**BEFORE THE HEARINGS PANEL
FOR THE QUEENSTOWN LAKES PROPOSED DISTRICT PLAN**

IN THE MATTER of Hearing Stream 08
– Business Zones

**REPLY OF VICTORIA SIAN JONES
ON BEHALF OF QUEENSTOWN LAKES DISTRICT COUNCIL**

12 QUEENSTOWN TOWN CENTRE CHAPTER

Figure 1 - Area x, with the 327.1masl maximum horizontal height plane

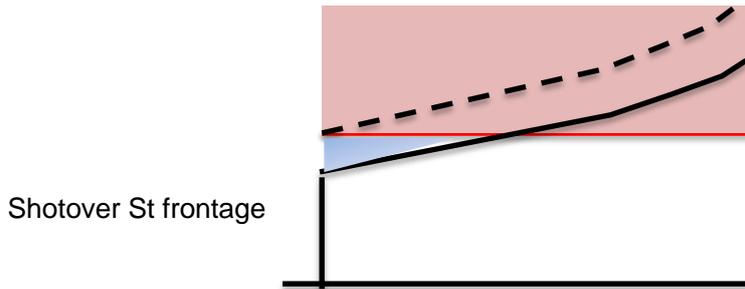
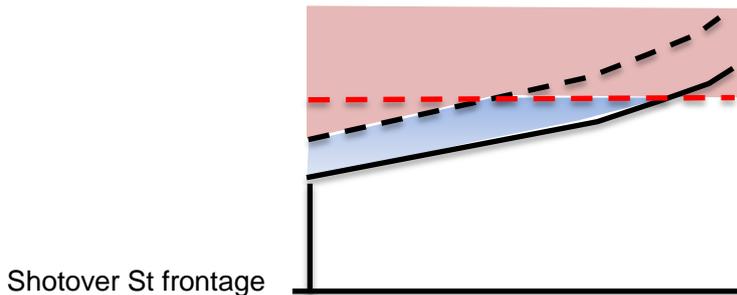
6.10 In response to the evidence dated 18 November 2016 and questioning of Mr Farrell, I now recommend that Areas E and F (as shown in recommended Figure 2) be removed from Precinct 7 and replaced with Precinct 1, and consequential changes be made to Rules 12.5.10.4 and 12.5.10.1. These consequential changes include adding a rule to 12.5.10.1 that no building exceed a horizontal plane at 271.1/ 330.1 masl. The recommended rules in **Appendix 1** will have the effect of providing the restricted discretionary activity status to buildings between 12 and 14m above ground level as in the rest of precinct P1, while ensuring that anything above either 14m above ground level or 227/ 330 masl respectively will be non-complying. This is considered more efficient and effective than redraft Rules 12.5.10.4(e) and 12.5.10.4(f) that apply to this area in the version attached to the S42A report.

6.11 The following cross sections are an illustration showing the various height planes that would apply respectively in the two parts of this block:

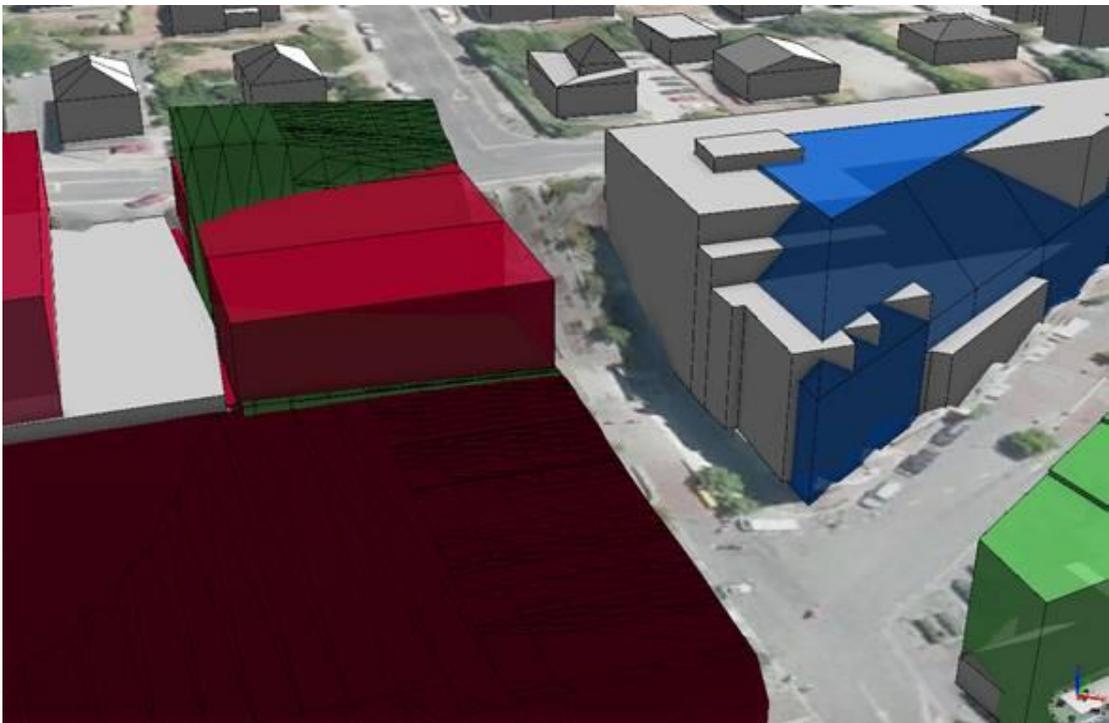
6.23 Due to the significantly different configuration of the allowable building mass over the three sites, which would result from Mr Williams' and Mr Edmonds' rules and given that 10 Man St is in different ownership to the other two sites, it is useful to consider how that particular site would be affected by those rules.

6.24 In summary, in my view it is likely that less development will be enabled on this site under the 7m rule sought than under the PDP; the site may obtain significantly lesser views to the lake (due to the level plane allowed over the 3 lots (10 Man, 10 Brecon, and 14 Brecon Streets); and the site is likely to need to be excavated below the level of Man Street to achieve well designed 2 storey development along Man Street, which in itself is not a good outcome.

Figure 1

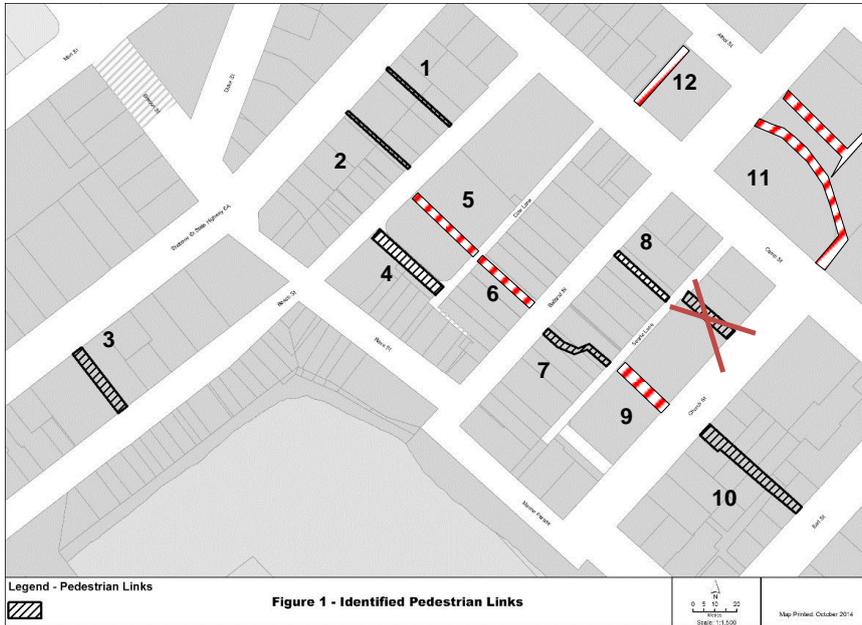
Comment [MSOffice186]: 2 plans are included in this version; the first showing the changes proposed to the notified version in red and the second showing the larger format final amended recommended plan and therefore should not be included in the recommended chapter.

Figure 2 - Queenstown Town Centre Height precinct map

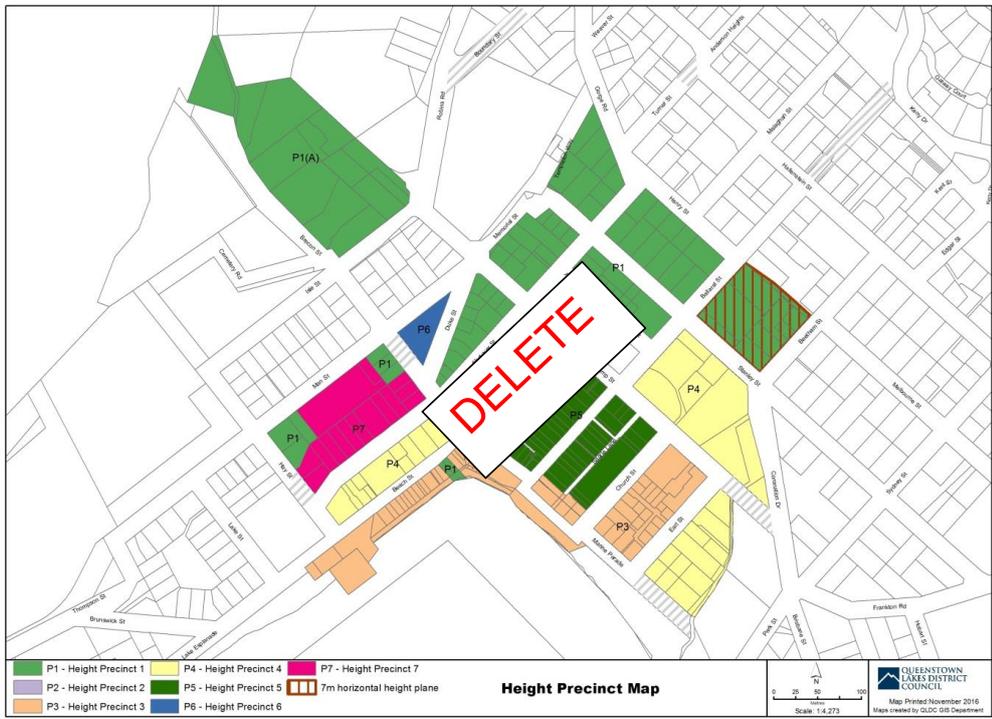
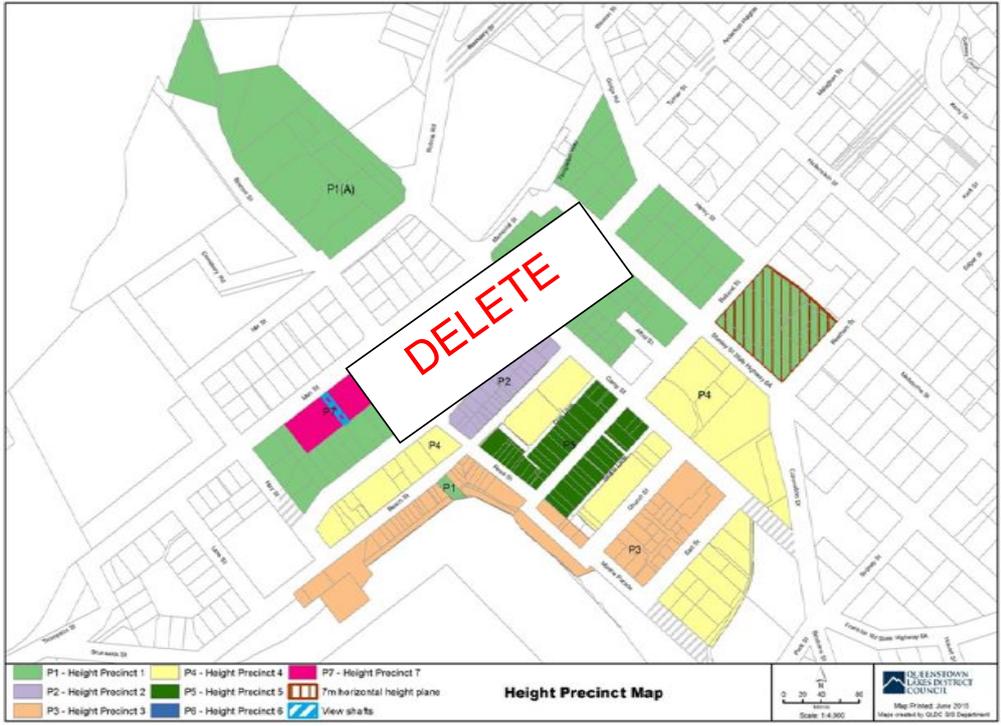
- 6.19** I have reconsidered the recommended location of the western viewshaft (recommended Area D), which I had relocated to the location specifically sought in paragraph 4.14 of MSP's submission (398). In response to the evidence of Mr Williams I now recommend that it be repositioned approximately 13m to the west to avoid the lean-to roof form that he refers to in paragraph 11 of his evidence summary. As a consequence of this, recommended Area B is reduced in size and, due to the rising level of Man Street, the height enabled in the viewshaft can be raised 0.5m (i.e. to 330.6m) without impeding on views from the street. This has the added benefit of enabling more design flexibility for the first floor beneath.

Comment [MSOffice187]: 417 (John Boyle), 398 (MSP), 383 (QLDC). The first version of the Figure below is as notified and the second version below (since recommended to be deleted) was introduced via the Council's memorandum dated 8 November 2016.

In relation to amending the height precinct P7 (E and F) to P1(i) and P1(ii) in the height precinct map (Figure 2) and subsequent changes to Rule 12.5.10.4.1, 12.5.10.4(e) and 12.5.10.4(f))

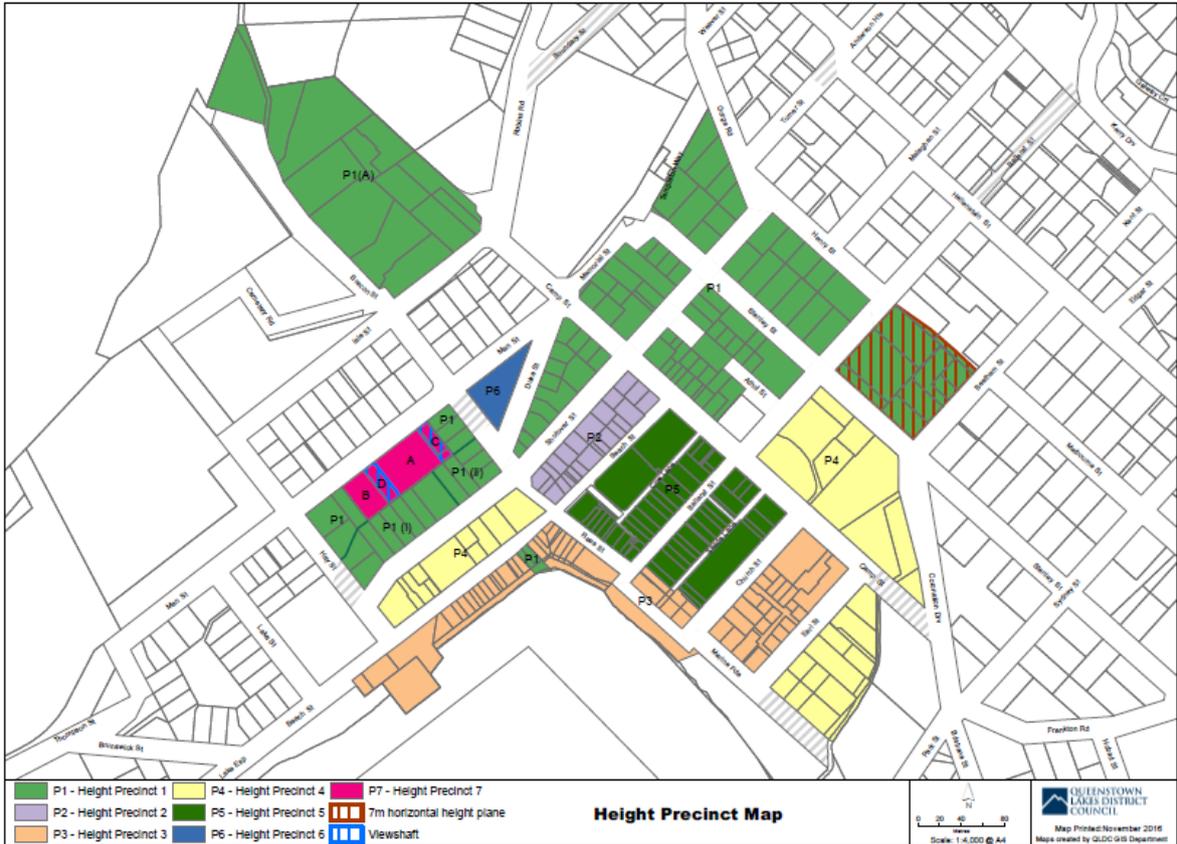
Note: P1(i) is the eastern parts of the block containing The Lofts, Hamilton building, and Salvation Army building along the frontage and P1(ii) is the balance land.
